# THE GIBSON

A NEW FREMONT RESIDENTIAL  
APARTMENT BUILDING

3421 & 3422 WOODLAND PARK  
AVE N, SEATTLE WA  
3032609-EG

RECOMMENDATION  
DRAFT

^ EDG Diagram of Massing Articulation

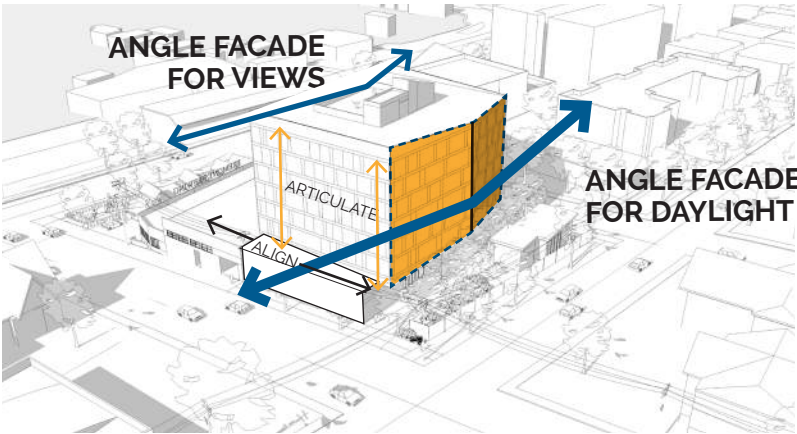
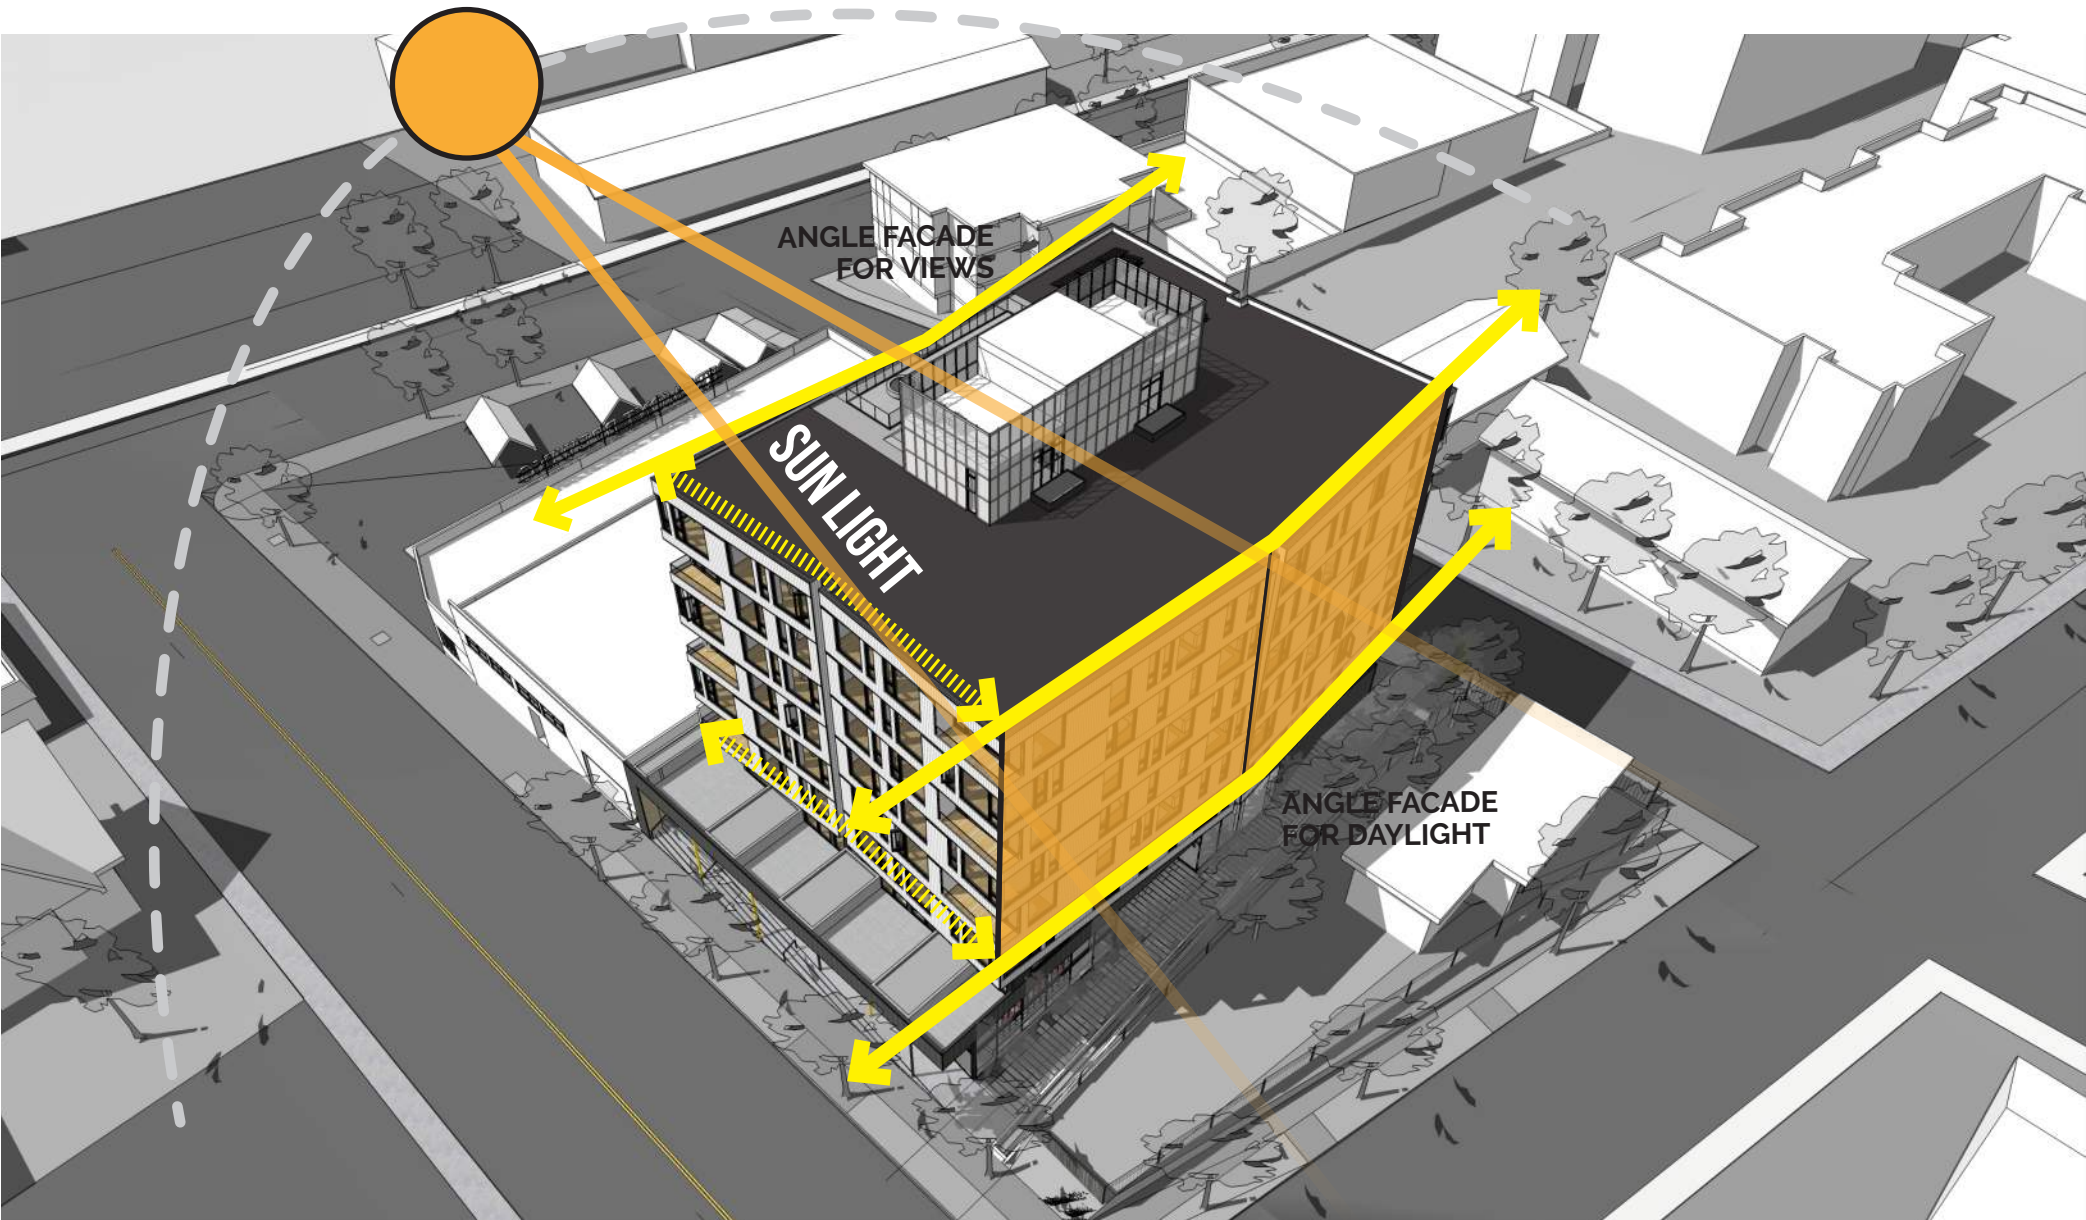
The Board expressed support for the preferred massing option: The angular shape of the massing is highly responsive to the present and future context, neighboring structures, and unique perimeter conditions.

- a. The Board unanimously supported Option B3, the applicant's preferred massing option, as it is highly responsive to the present and future context, neighboring structures, and unique perimeter conditions. (CS2)

- b. The Board supported the subtle and sophisticated sculpting of Option B3, and stated it appears to be light and fun in comparison to the blocky and conventional form of options B1 and B2. In agreement with public comment, the Board encouraged further development of the overall architectural character in a manner that expresses the whimsy and quirkiness of the Fremont neighborhood and specifically prioritized Design Guideline CS2-A, Location in the City and Neighborhood, and CS3A, Emphasizing Positive Neighborhood Attributes. (CS2-A, CS3-A)

The massing scheme from the EDG has been maintained and the angular shape of the massing is preserved in order to provide sunlight to the north neighbor and create opportunities for views along the south. Additionally, the angular shape and sculptural form of the building enhance the artistic vibes of the Fremont neighborhood allowing the building to establish a sense of place along the neighborhood block. CS2-A (Sense of Place and Architectural Presence)

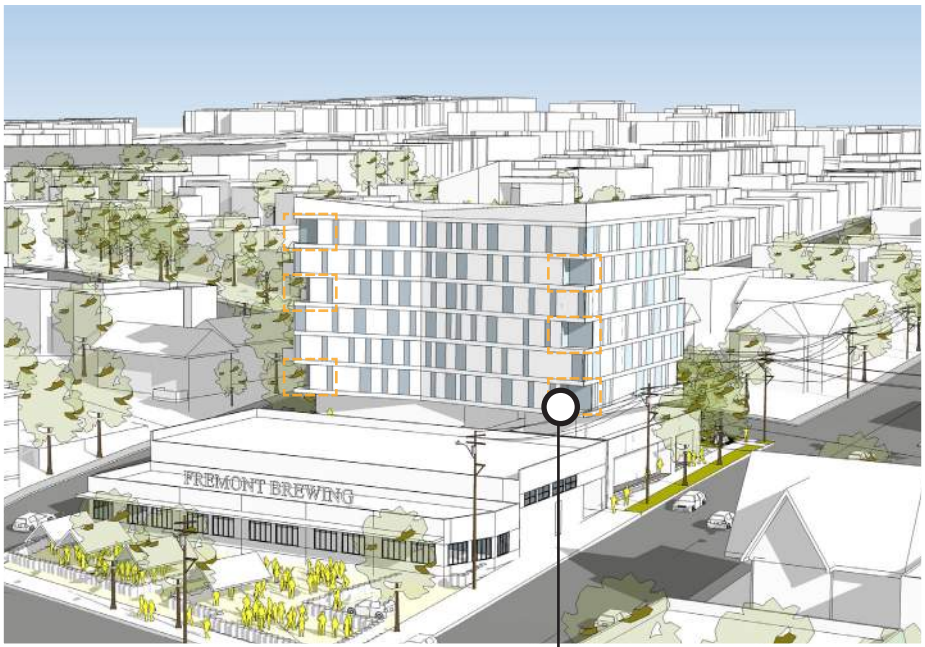
# The board supported the eroded corners which successfully elevated the massing scheme and suggested further additions of recessed balconies to gain advantage of the views.

c. In agreement with public comment, the Board supported the eroded corners concept. The Board noted this feature is important to the success of the mass and should be expanded upon – see additional guidance below under #4.a. (DC2)

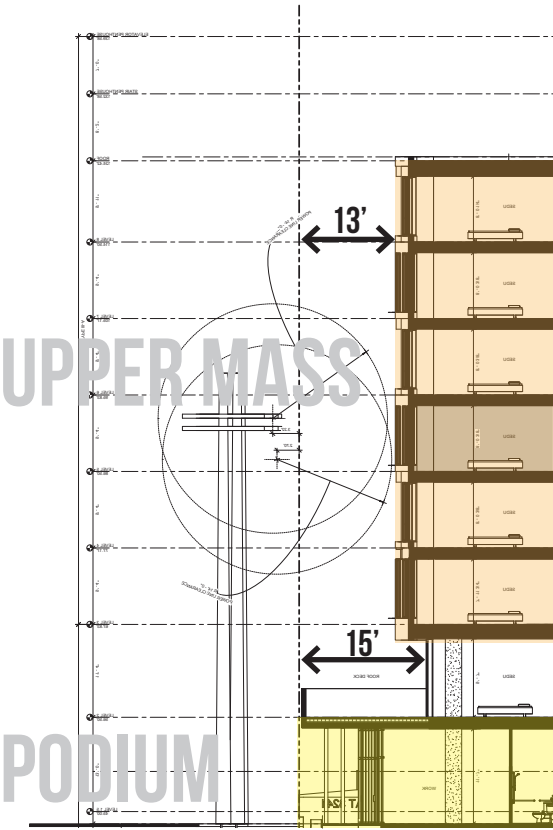
e. The Board supported the response to the existing commercial datum to the south along Woodland Park Ave N and the resulting upper-level setback above the live/work units. (CS2-B, CS3-A-1, DC2-A-1)

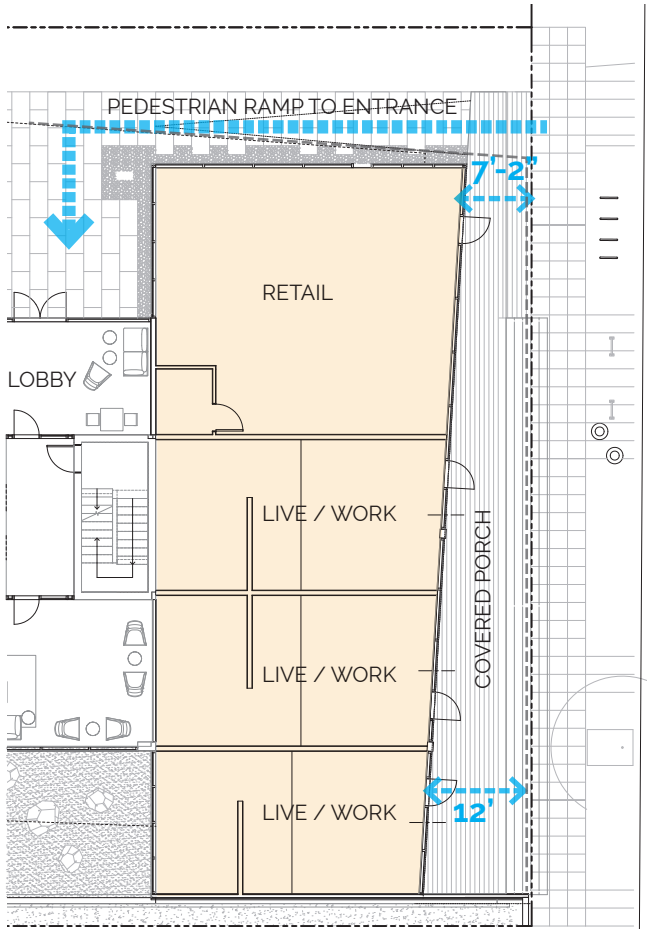
# The board supported the location of the residential entrance and provided guidance to integrate **ramping and stairs**. The board suggested more **transparency** at the entry sequence by **avoiding blank walls at the corner** of the entrance.

The scale of the pedestrian entry connector is broken down through change in materials and additional landscape plantings.

< Live / Work Units along Woodland Park Ave echo the commercial quality of the street and provide architectural transparency at the entry corner

Ground Floor Plan  
Scale: NTS

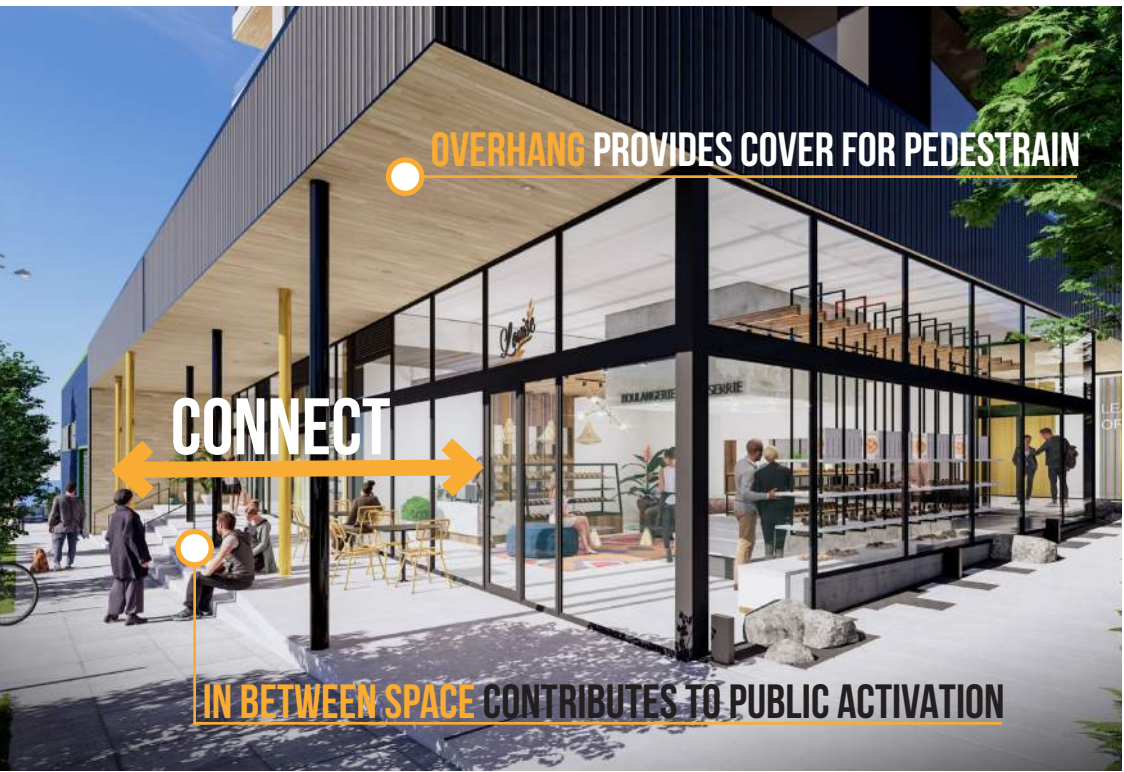
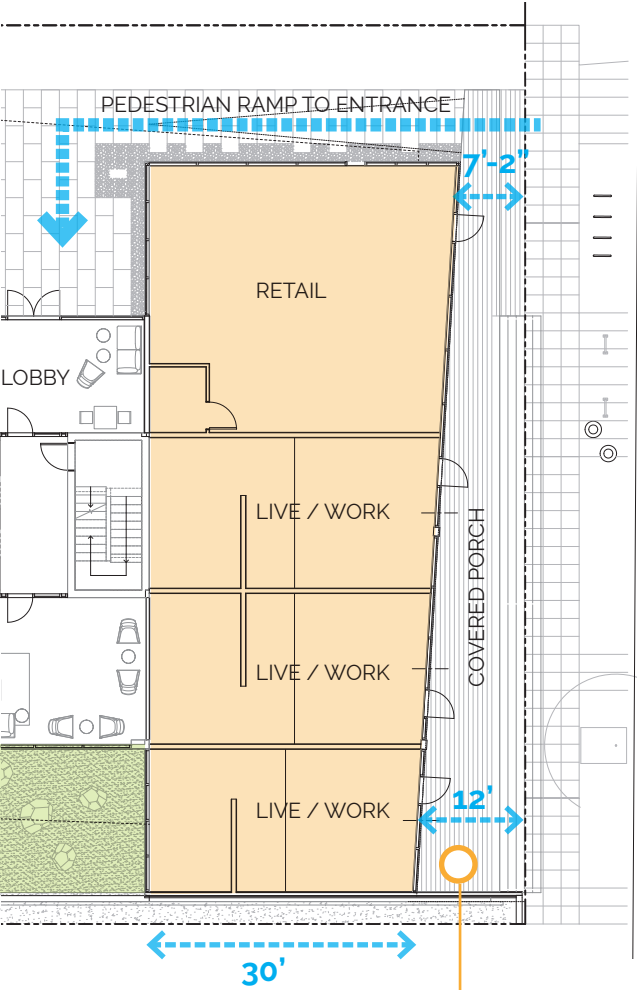
The board supported the location of the live/work units and the transition between existing commercial use and the residential use. The board provided guidance to contribute to the pedestrian realm.

The proposed location of the live/work units and retail program have been maintained at the northeast corner of the site providing a good transition between the existing commercial spaces on the north and south and the new residential structure.

To enhance the sense of pedestrian activation along these units, an angle was created (*akin to the angles along the upper level mass*) along the ground plane that expands the depth of the covered porch area under the building overhang. This area will allow for spill out space and informal gathering opportunities along Woodland Park Ave N.

The live/work unit depths have been re-configured to ensure the 30' required commercial depth (15' min for the business portion of the unit), so no departure is needed, though the secondary entrances from the west have been eliminated in an effort to provide needed egress and exiting and a courtyard space off the south lobby.

^ EDG Diagram of Albion Place N Residential Entries, Vehicular and Solid Waste Storage Access

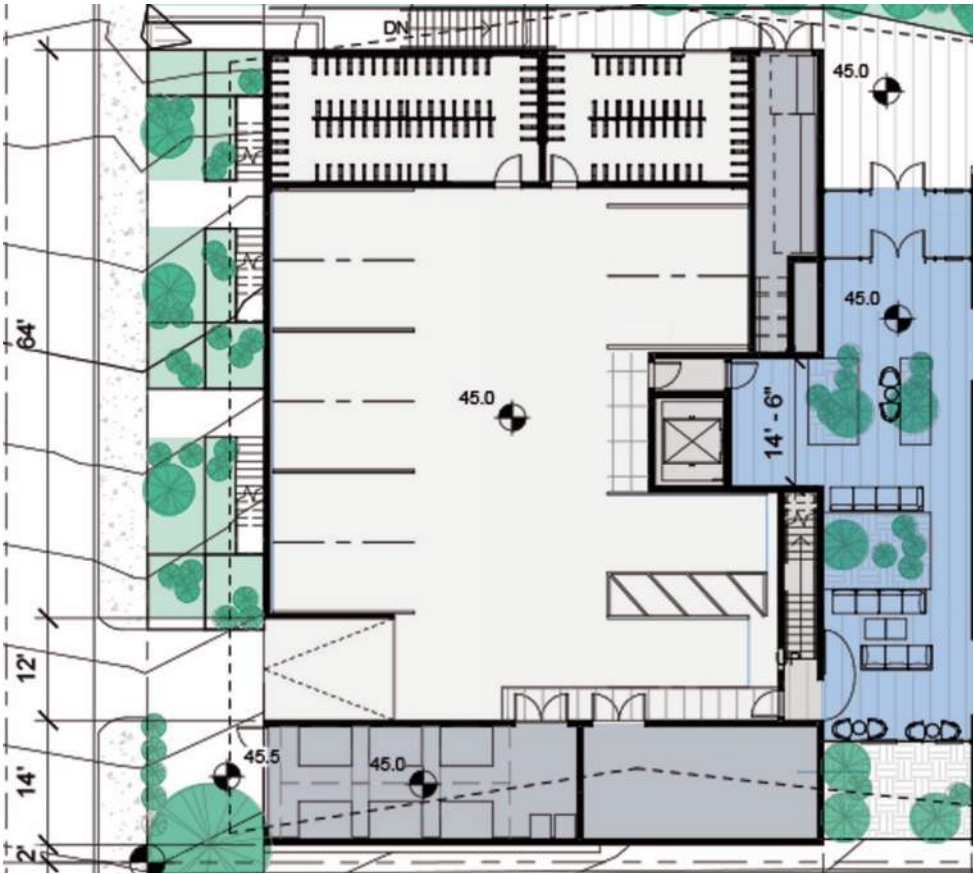
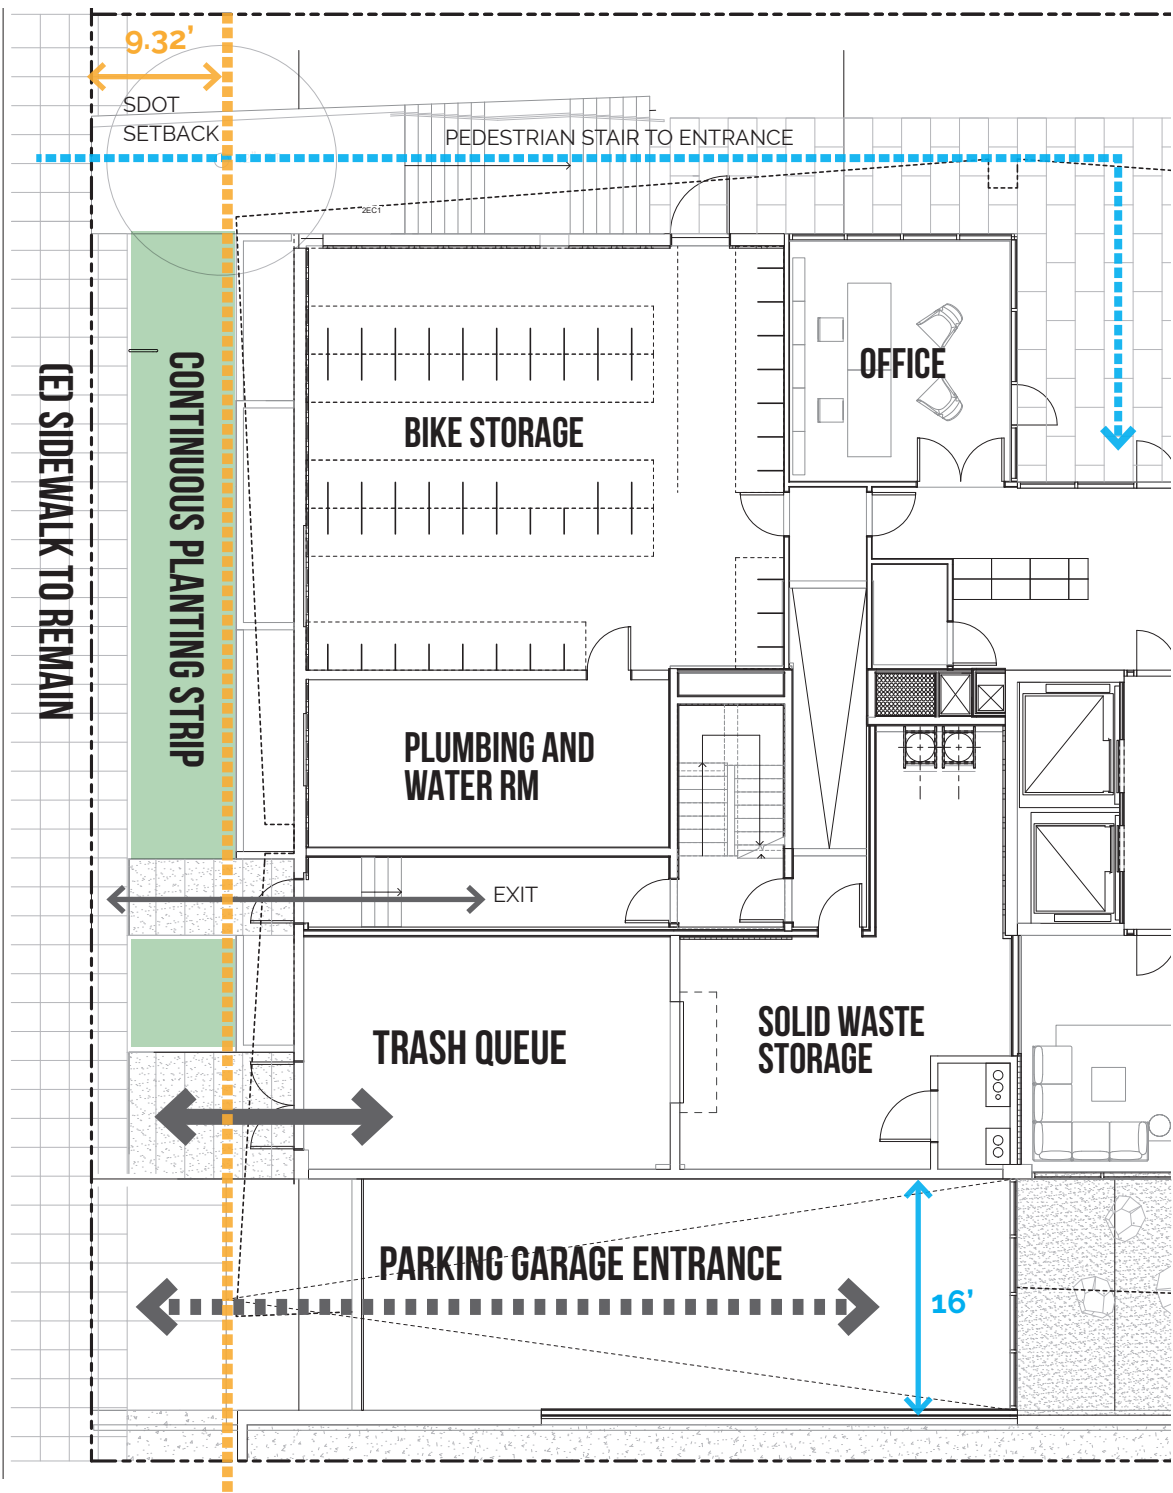
The board supported the use of planting strip as the transitional element between the curb and residential units as it helps buffer the residential units. The board supported the proposed trash storage and services plan.

- a. The Board supported the proposed individual entries along Albion Place N as it maximizes eyes on the street. Stoops should be designed to be usable spaces and contribute to a residential character. (PL2-B-1, PL3-A-3, PL3-B, DC2-D-1)
- b. The Board acknowledged SDOT comments regarding the preferred planting strip location along Albion Place N; however, the Board noted that locating the sidewalk between the curb and the planting strip helps buffer residential units by creating a more contiguous landscape along the property line. (PL3-B, DC4-D-1)
- c. The Board supported the proposed trash storage, staging and service plans. (DC1-C)

- a. The design team evaluated the program with the client and consultant team following the Early Design Guidance meeting and determined that the ground level needed to be slightly modified in order to accommodate some additional bike storage and plumbing / mechanical rooms. Keeping with the idea of preserving the commercial base datum, the design was adapted to maintain the commercial look around the base of the structure, with landscaping and access doors for trash and the parking garage.

- c. Per design guideline PL1-A1 "Enhancing open space" the existing sidewalk condition has been left in its original place to maintain the traditional block condition and more meaningfully connect to the broader open space network that is existing. All pedestrian access has been designed to integrate with this condition and the design team agrees with SDCI regarding the larger, continuous planting strip adjacent to the building.
